CITY OF ALBUQUERQUE

June 6, 2008

RE: **Sunrise Assisted Living @ Paradise Hills** (B12 – D 012)
(Approx. - 10101 Golf Course Road NW)
Grading and Drainage Plan for Building Permit (PE Stamped 5-28-08)

ENGINEER'S SEAL 	SUNRISE SENIOR LIVING PARADISE HILLS PERMIT REVISION SET ROUGH GRADING PLAN	DRAWN BY DFT DATE 5/27/08
TIERRA WEST, LLC 5571 MIDWAY PARK PLACE NE ALBUQUERQUE, NM 87109 (505)858-3100	SHEET # C3	JOB # 27109

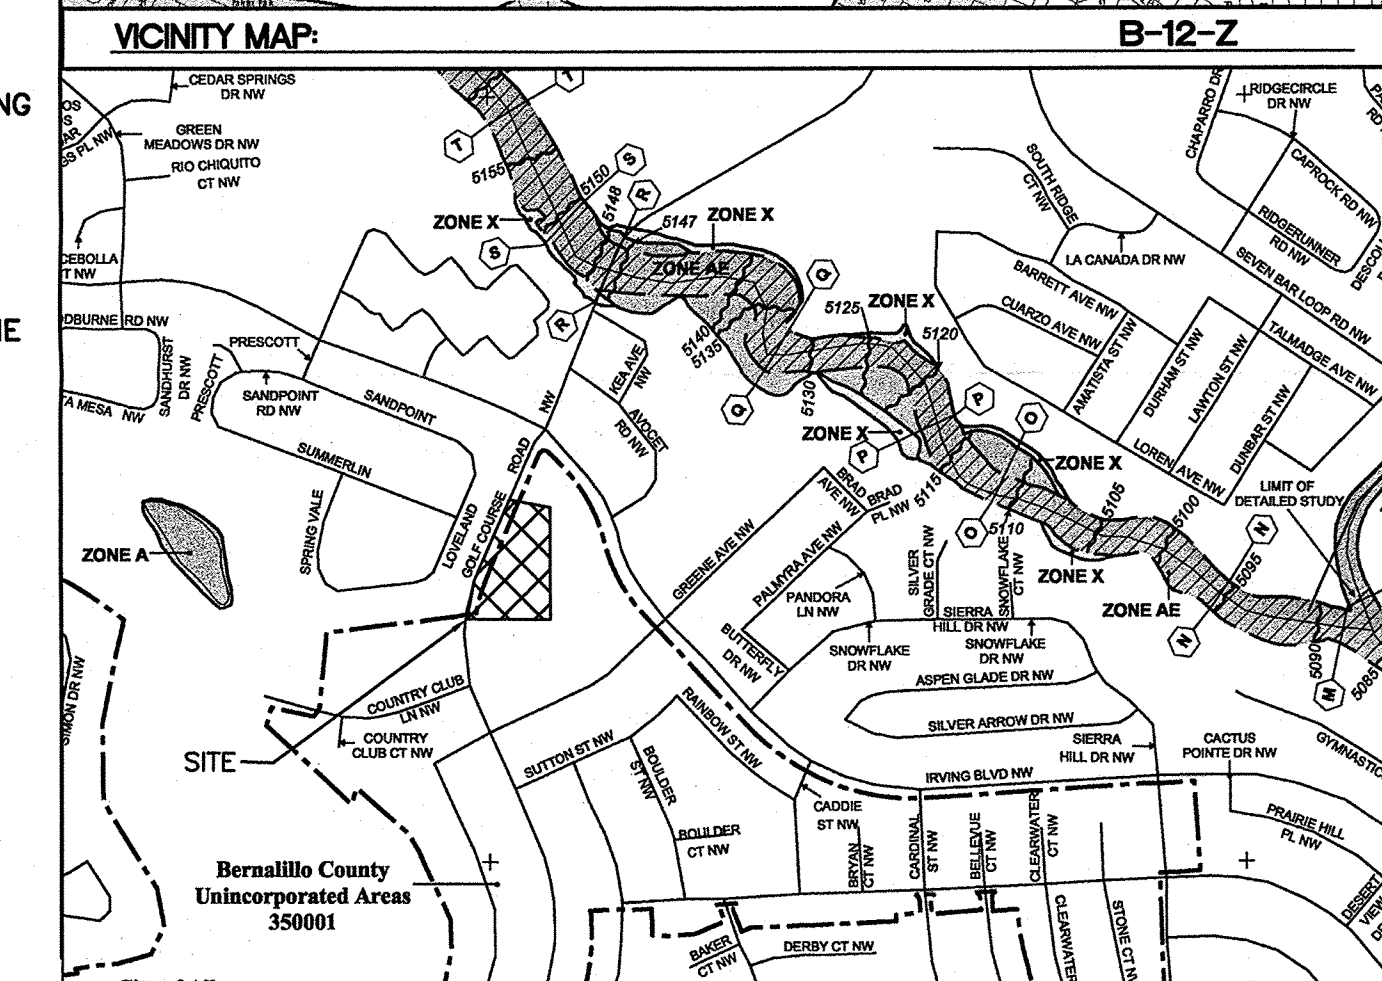
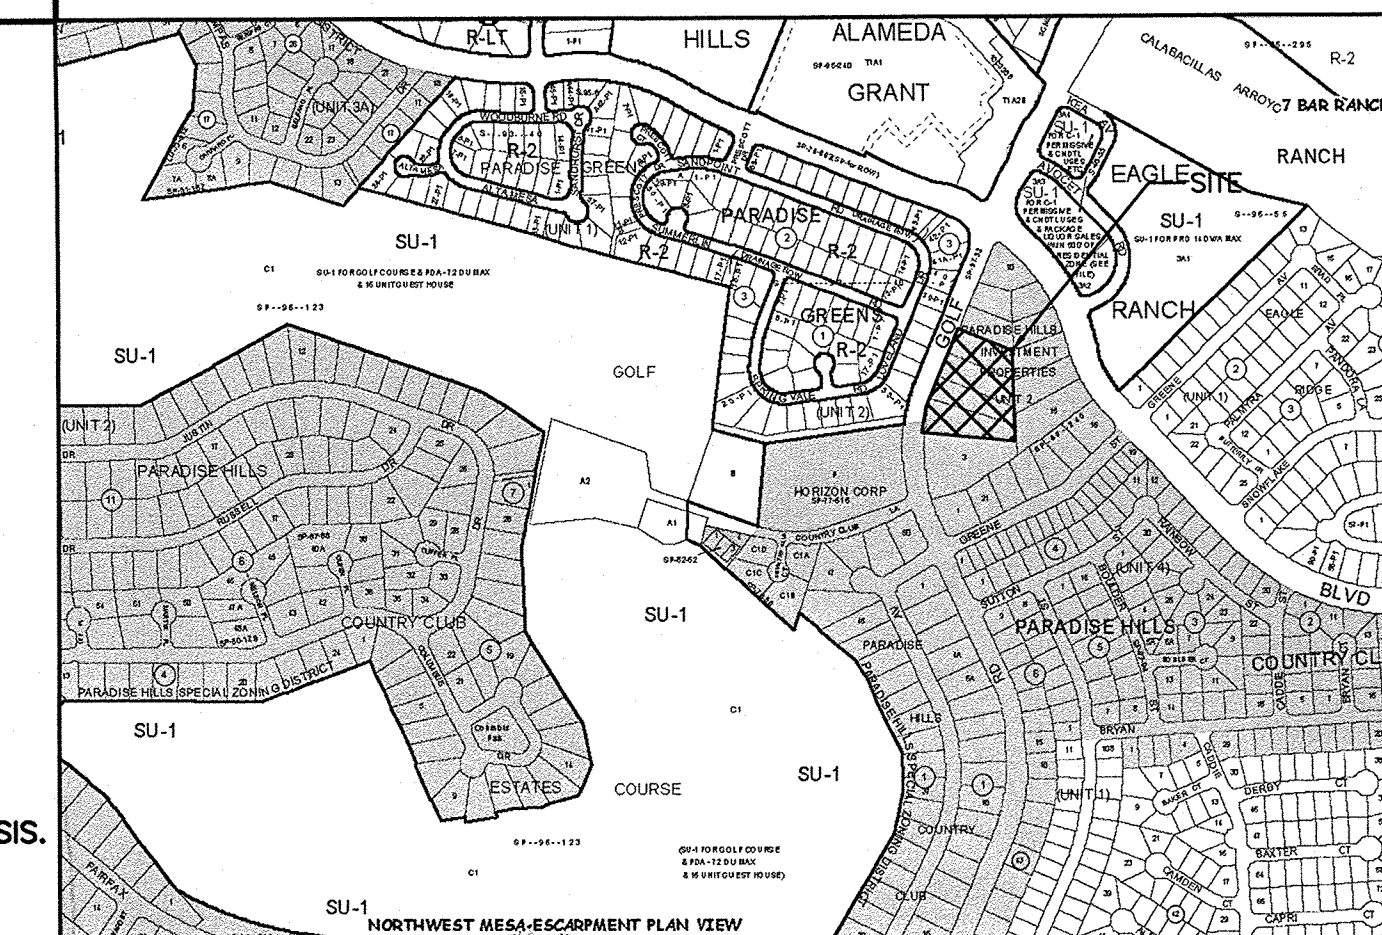
Based upon the information provided in your submittal received 5/30/08 with revised sheets C3 & H-2 received 6/6/08, we concur with the above referenced Grading and Drainage Plan allowing FREE DISCHARGE of storm water run-off to Golf Course Road in compliance with the Drainage Report prepared by Smith Engineering in 2003. The Smith report allows up to 10.61 cfs discharge to the basin draining north from the site.

Free discharge of the southern portion of the site is allowed to Golf Course Road, where it slopes to the south. The majority of the undeveloped site run-off must be routed through the proposed desiltation pond, and must enter the R/W over the existing concrete driveway. Future development and storm drainage analysis for the southern tract must avoid discharge over the sidewalk, and will require City of Albuquerque permits for any construction of driveway or sidewalk culverts in City R/W.
